Title		D-SUB & DDC & H, V SYNC	
Size	Document Number	Rev	A
Custm	A/C S15VD		
Date	Monday, December 11, 2000	Sheet	7 of 8

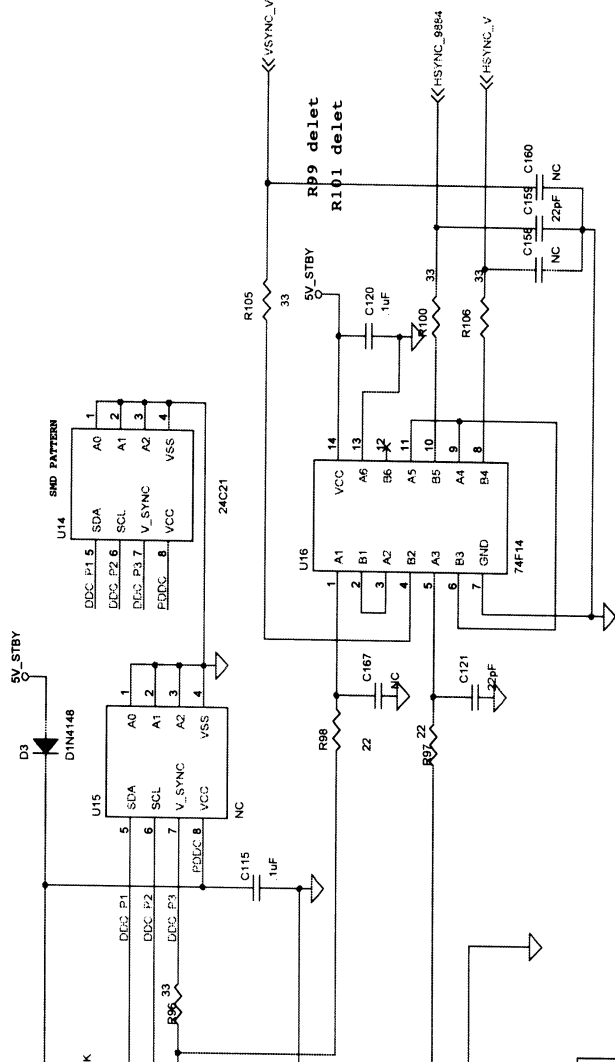
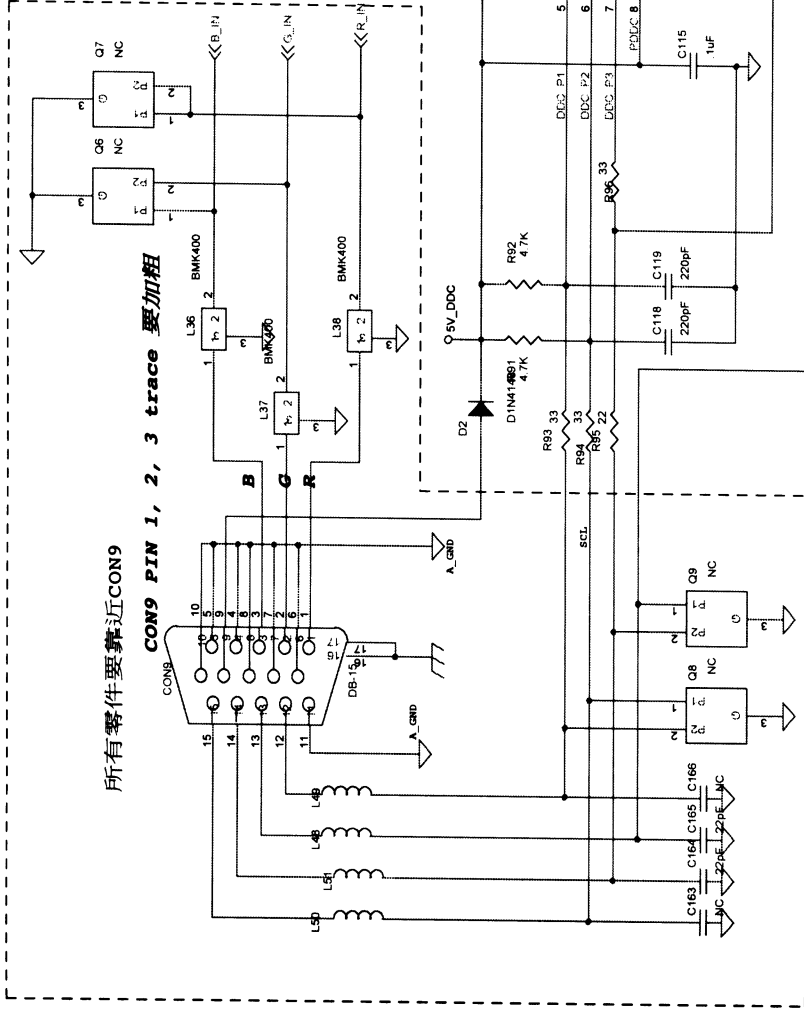
所有零件要靠近CON9

CON9 PIN 1, 2, 3 trace 要加粗
